**SAN ANTONIO WATER SYSTEM
Interdepartment Correspondence Sheet**

Subject: Zoning Case Z2022-10700174 (Wilderness Oaks Apts.)

Date: August 26, 2022

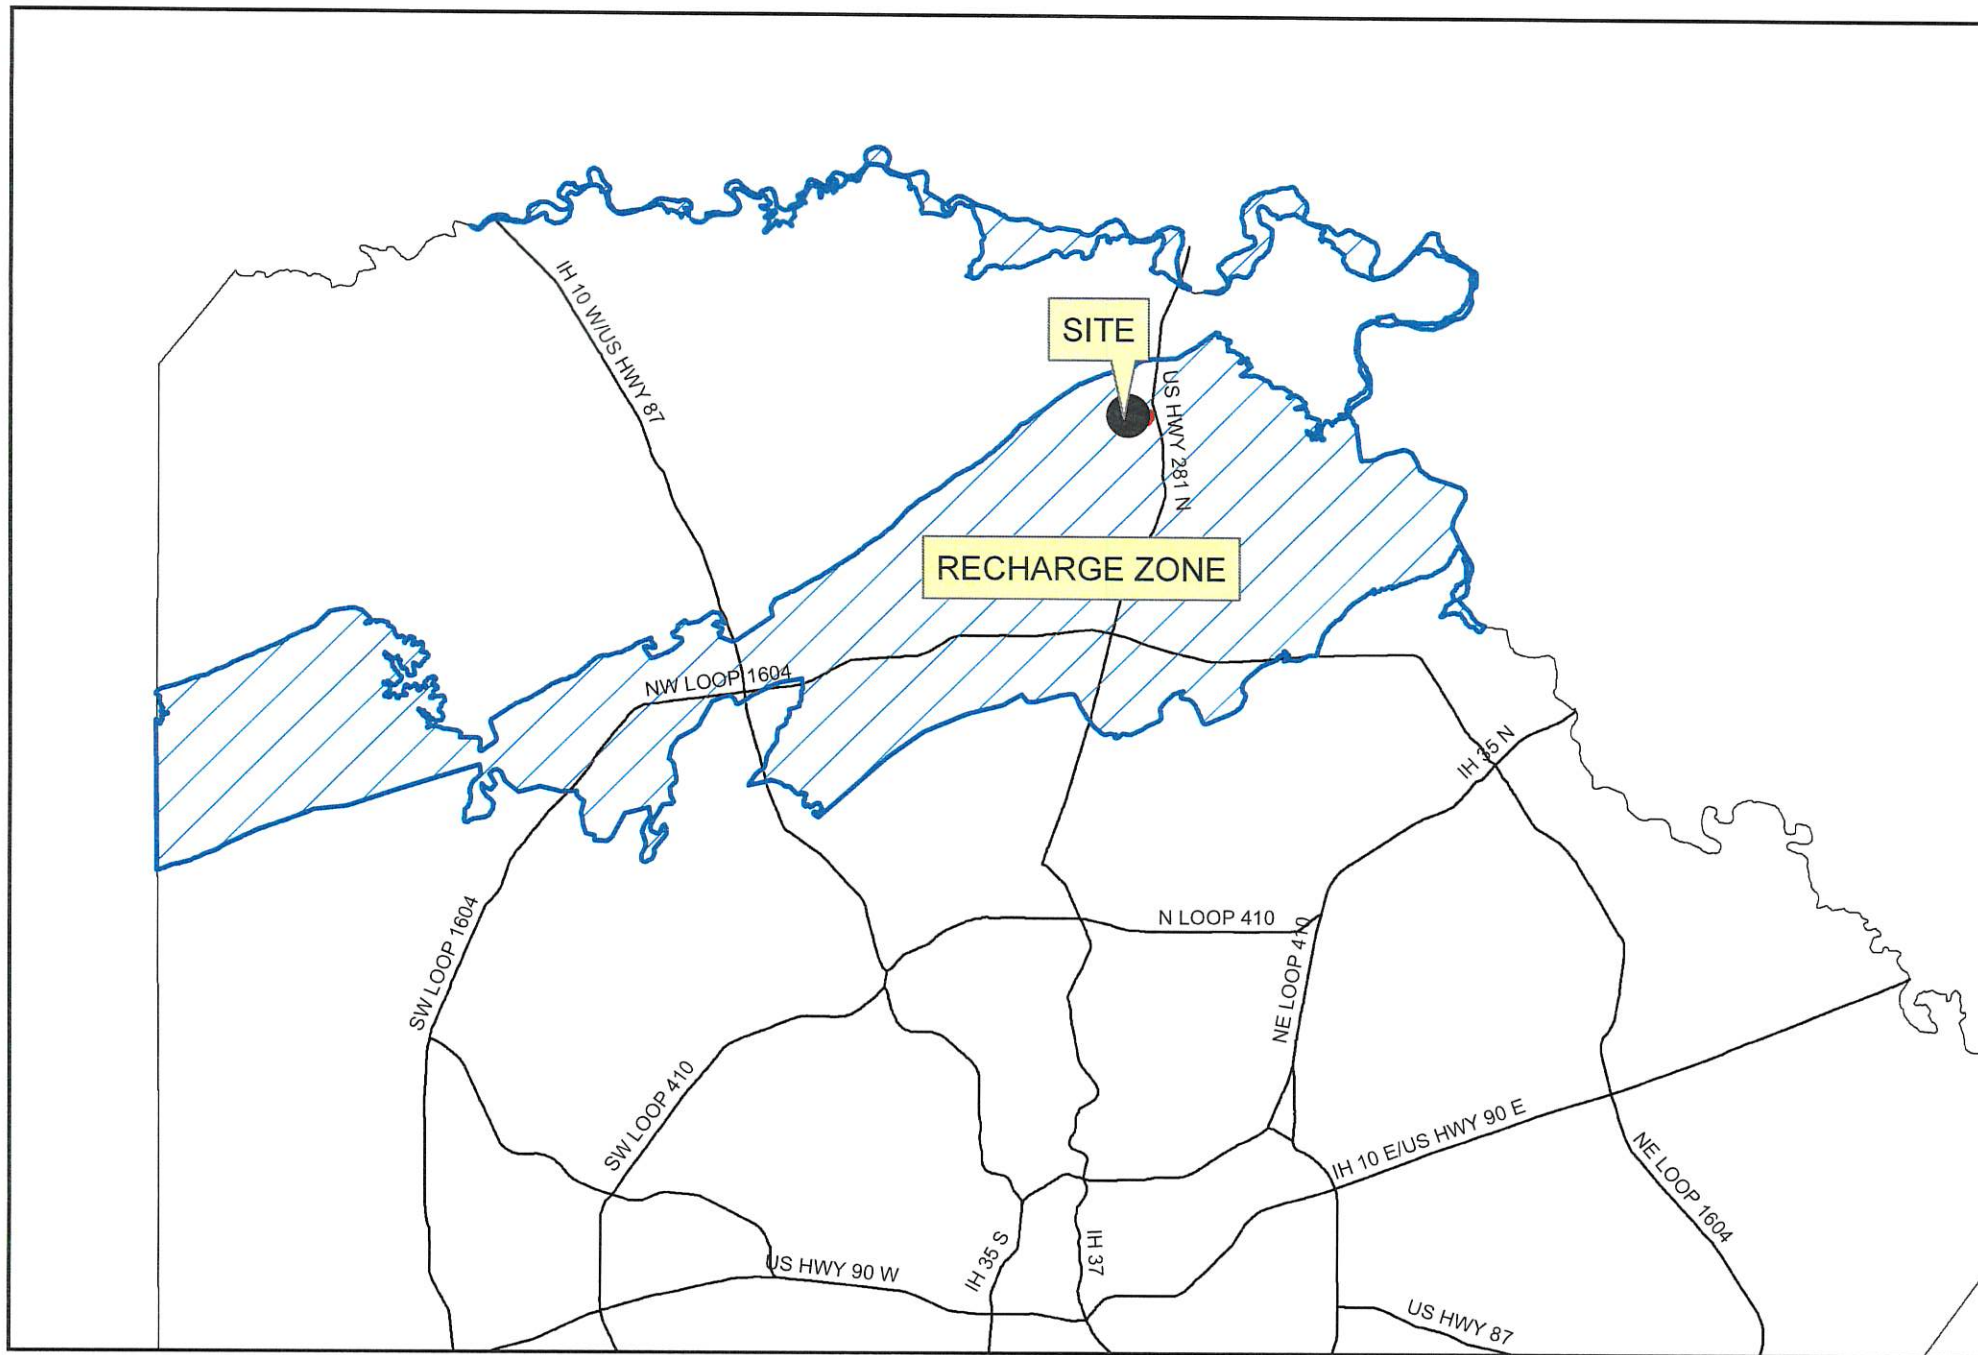
1. The impervious cover shall not exceed 50% on the approximately 19.37-acre site.
2. A natural buffer shall be provided for the sinkhole located on-site as required in Ordinance No. 81491, Section 34-920. The location of the natural buffer is further shown in the submitted conceptual site plan, attached as Figure 3. The intent of this exhibit is to show the location and buffering of the sensitive geologic feature, however, the remainder of the site is subject to change.
